SONARtrac® Technical Bulletin

Subject: 4-20 mA Output Change

TB001

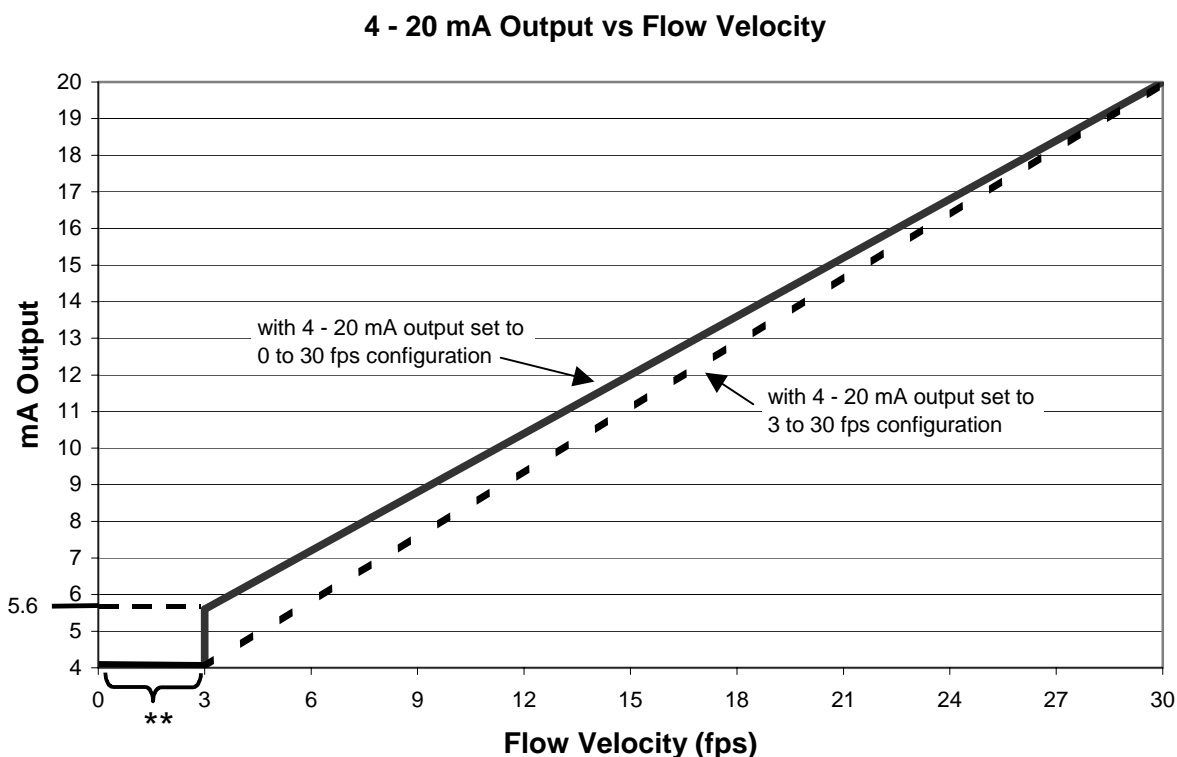
Software Version 01.05.10 and above changes scaling of the 4 – 20 mA output from 3 – 30 ft per sec to 0 – 30 ft per sec.

This change is represented graphically as follows:

At the system Low Flow Cut Off of 3.0 fps, the value from the 4 – 20 mA output will be 5.6 mA.

**At flows less than 3.0 fps, greater than 30.0 fps, or if the meter is not working, the display will read as configured in the setup of the output (i.e. 'Hold' (at last value), <4 mA, 4 mA or >20 mA).
